REVISION 1 5-31-72 P.D.A.

CITY OF HARTFORD, CONNECTICUT
DEPARTMENT OF ENGINEERING

SETTLING TANK AT POPE PARK POOL

DWG. No. R1A

GENERAL NOTES

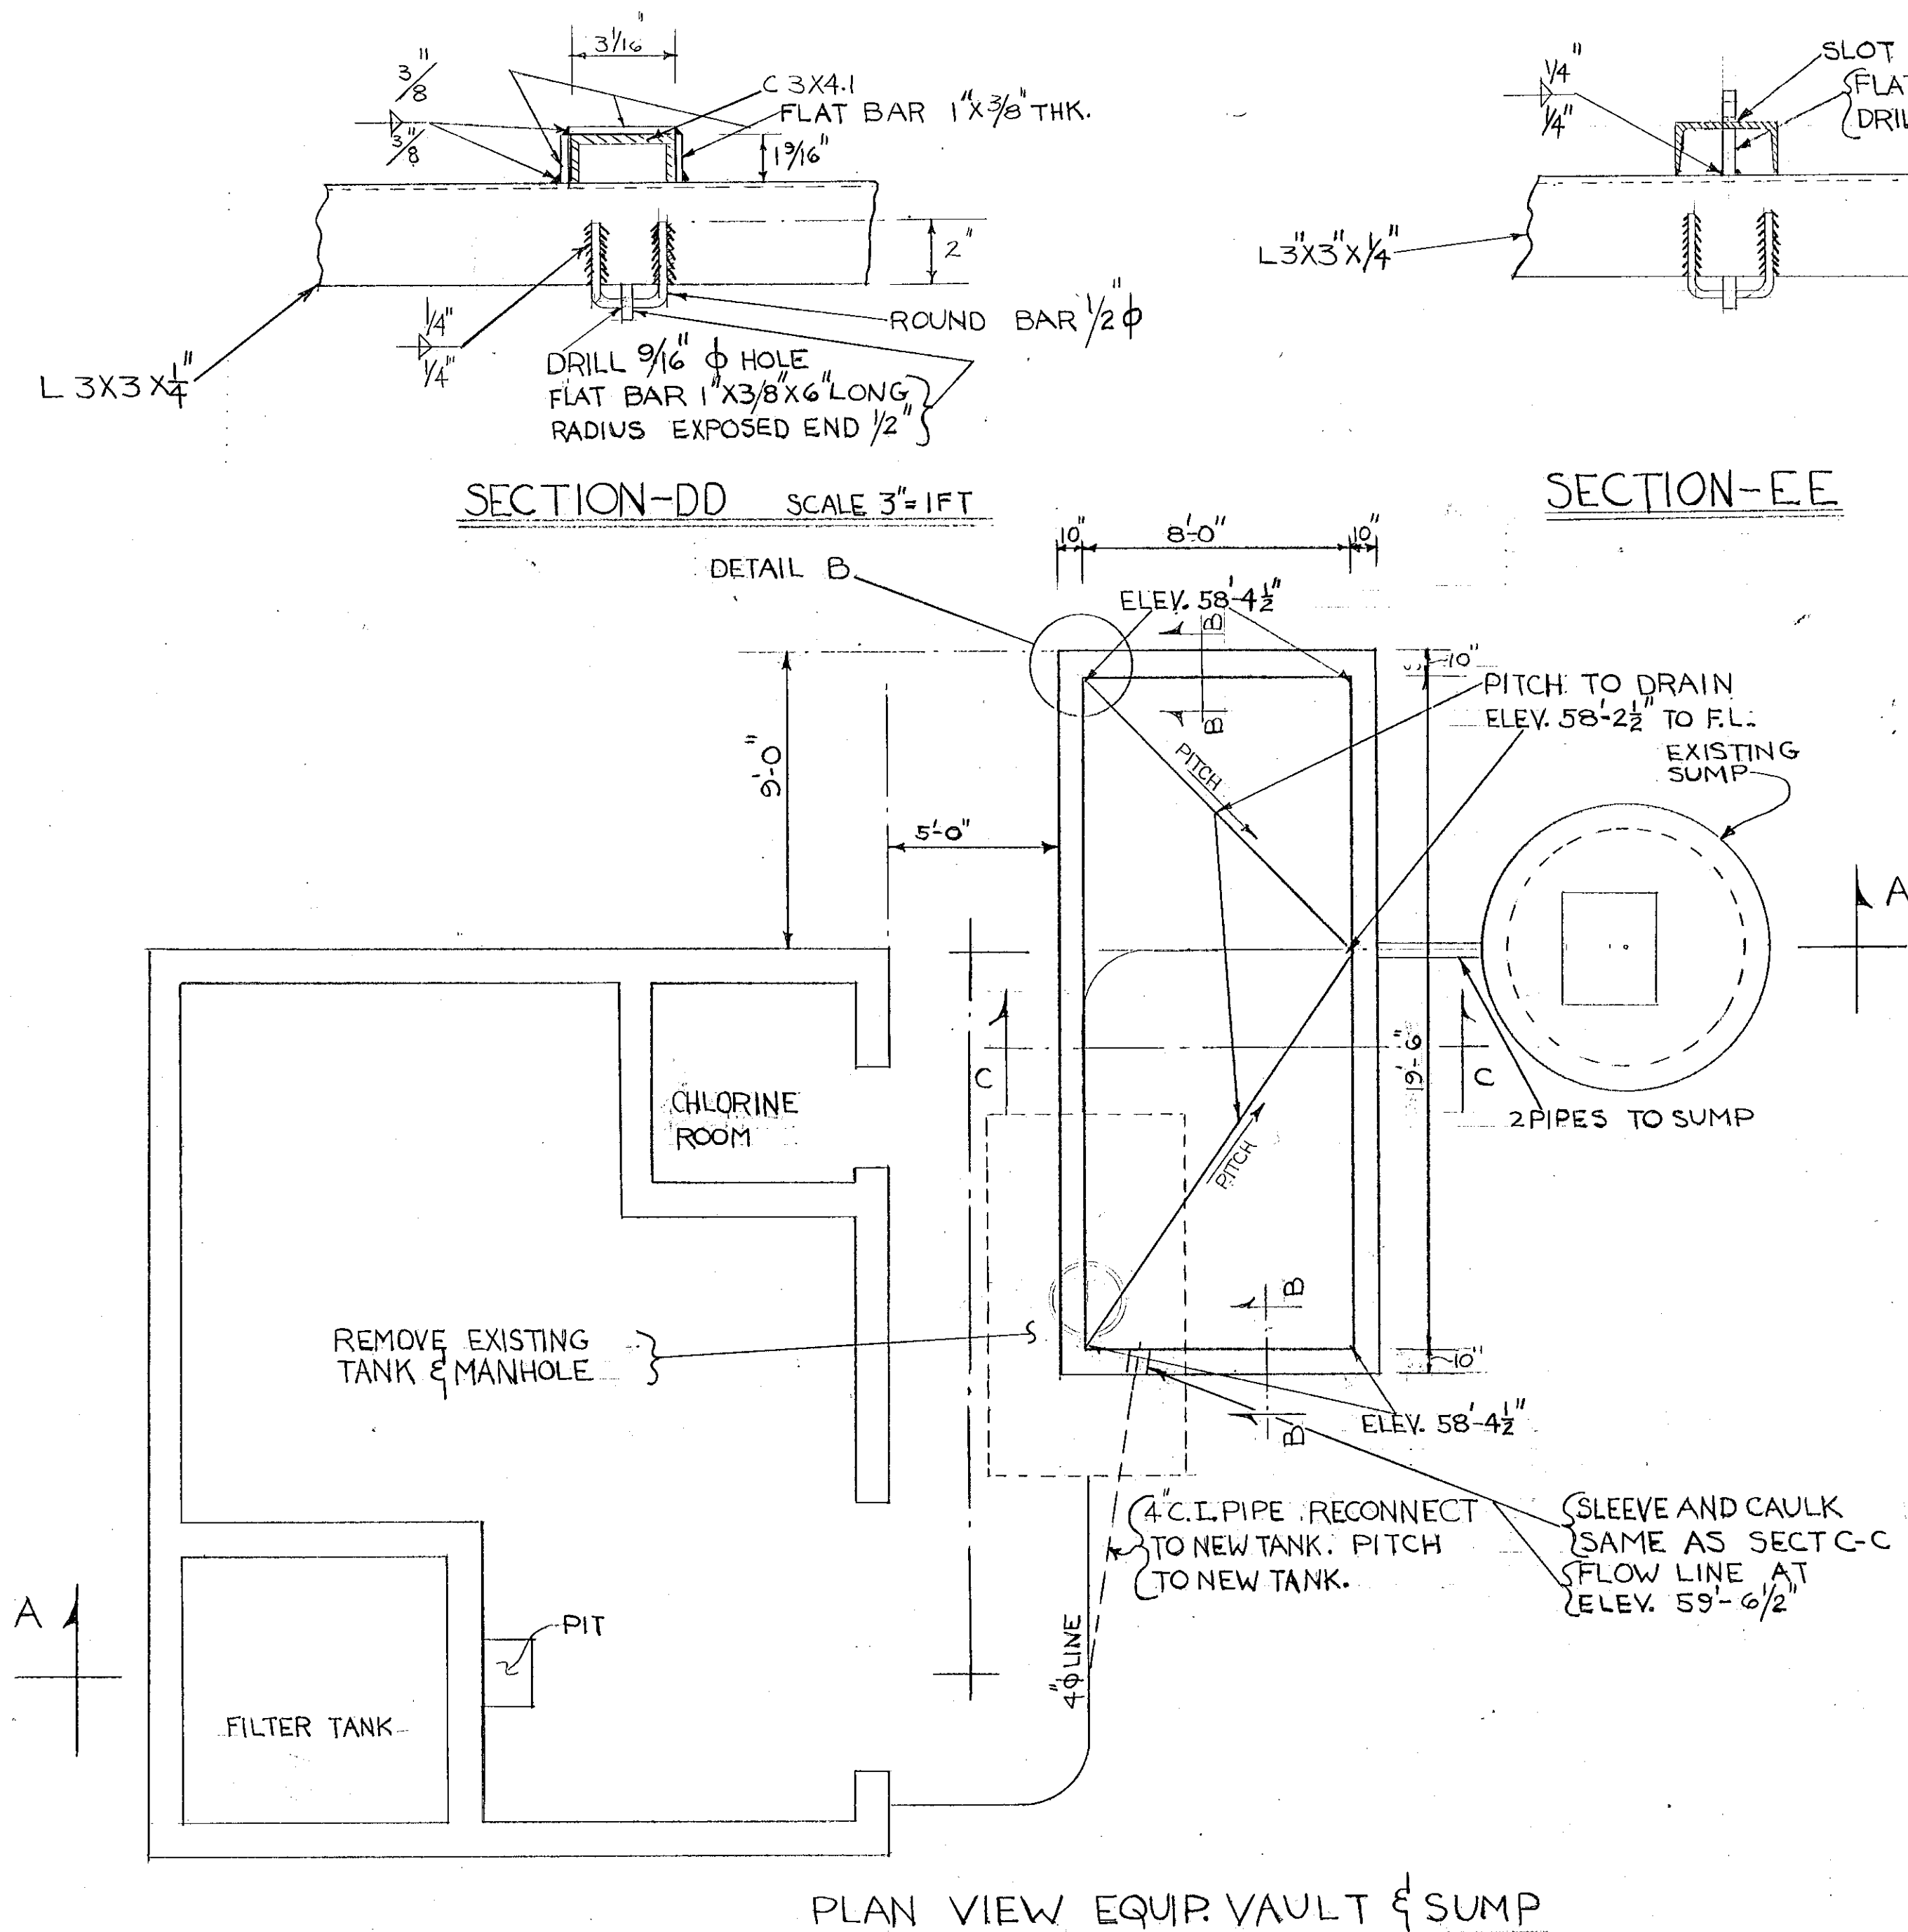
1. CHANGED SLAB & WALL THICKNESS (9" - 10")
2. CHANGED REINFORCING BAR SIZE (#4 - #5)
3. CHANGED METAL DECKING GAGE (18 - 16)
4. ADDED NOTES #7, #8, & #9
